Doorway | Runtime and planning restrictions

10 cm cells. Both panels show the same revised probe lines and intended stops. Diamonds are the existing macro launch points.

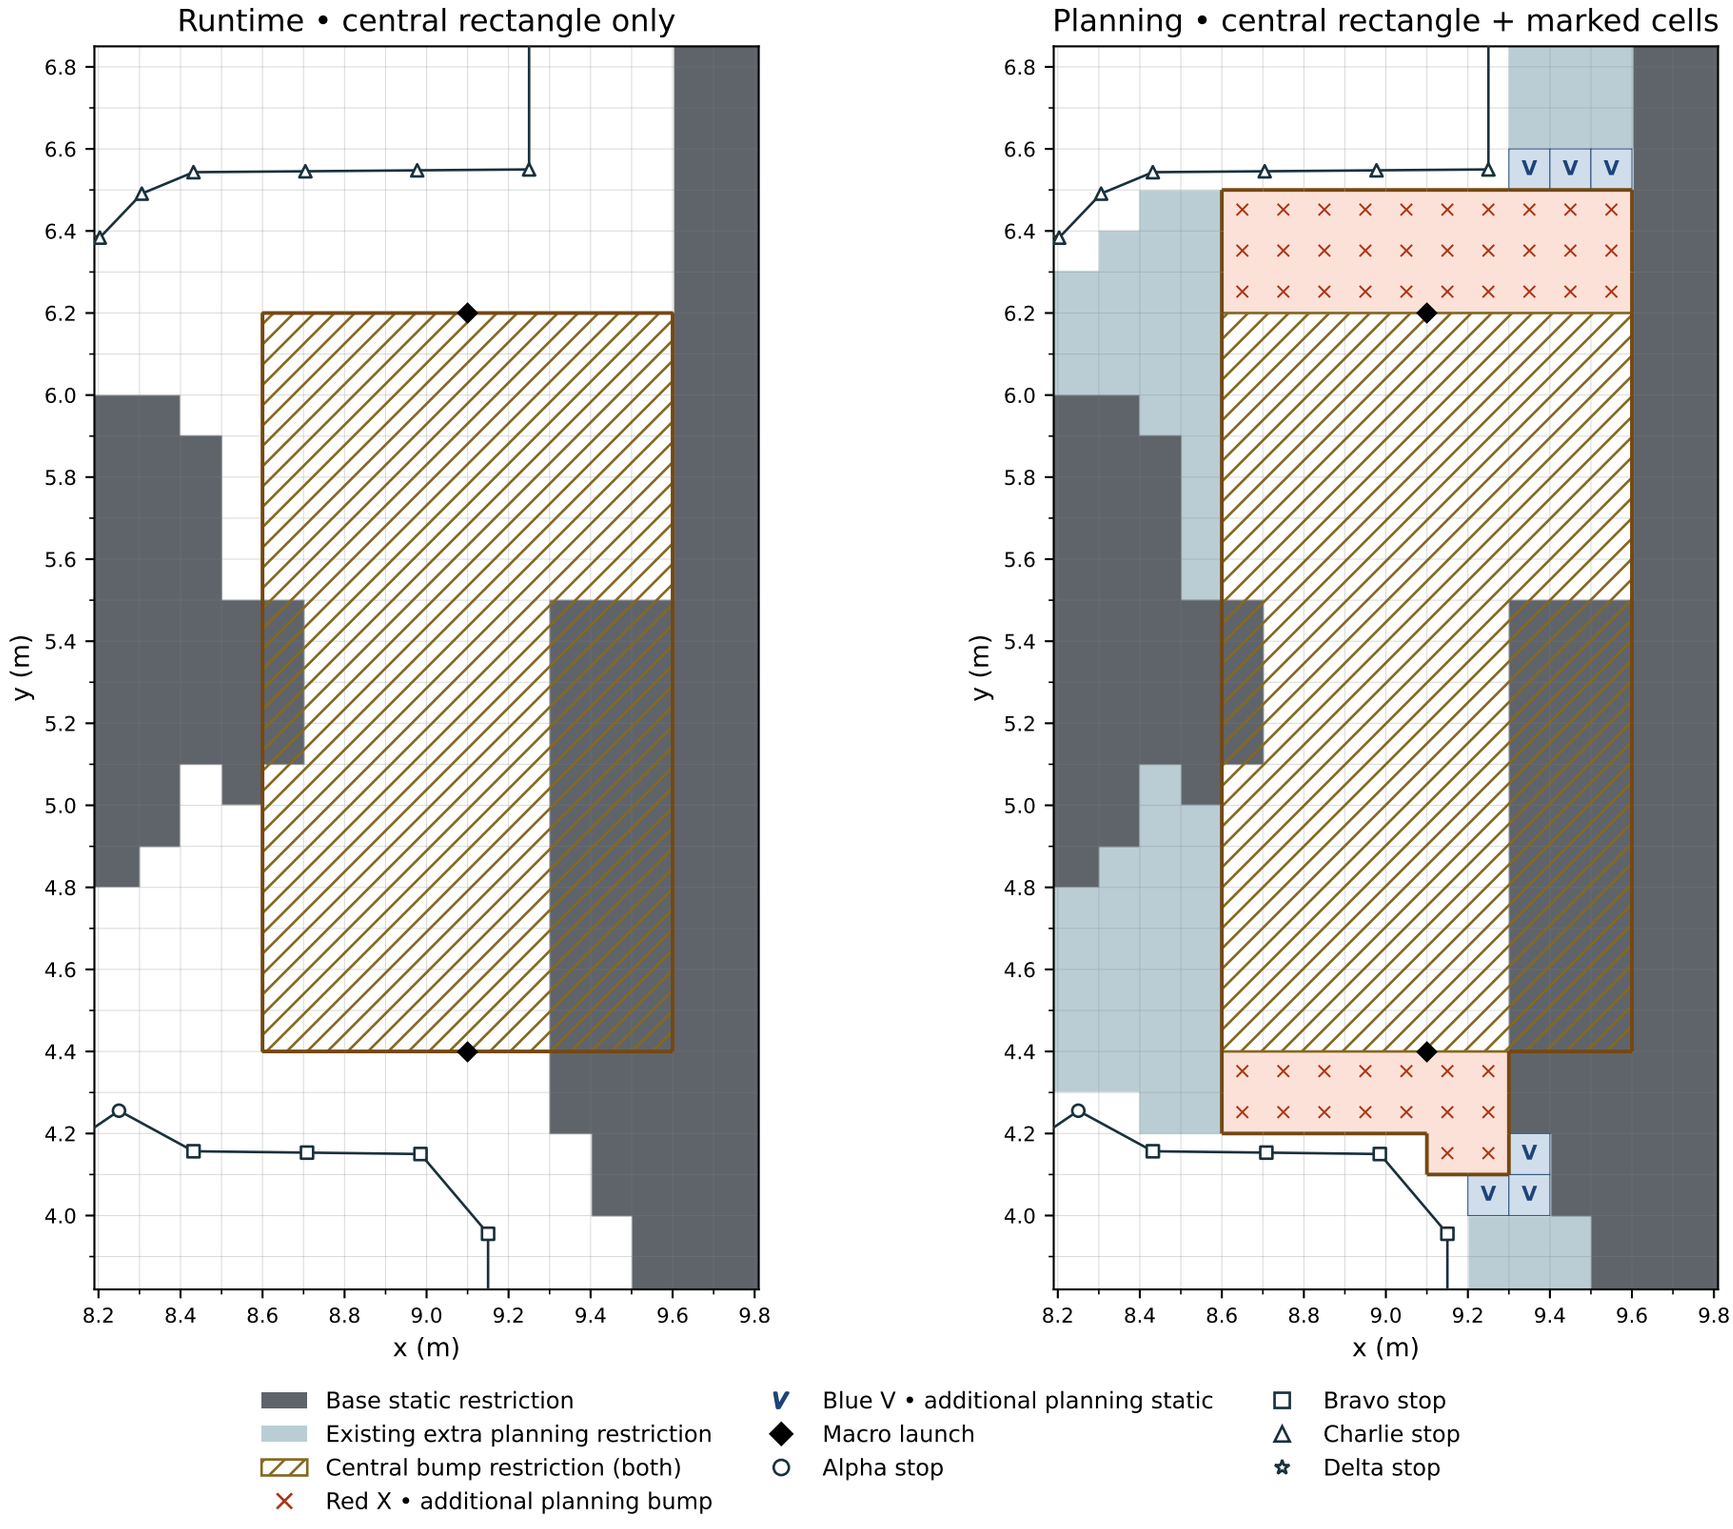
Static blocks remain blocked where layers overlap. Hatched and X cells denote bump rules, not a general ban on authorized crossing macros.

236 of 236 revised probe targets and 236 of 236 connecting segments stay outside the proposed exclusions.
Runtime bump overlay: 180 cells. Planning bump overlay: 226 cells. Normal planning additions: 6 cells.

Both launch positions, (9.1, 4.399) and (9.1, 6.2), lie in the red planning extension. An ordinary staging move from outside would enter the planning bump zone. The staging rule must be resolved before registration uses this layout. This is a review drawing; no operating maps, macro positions or checker rules were changed.
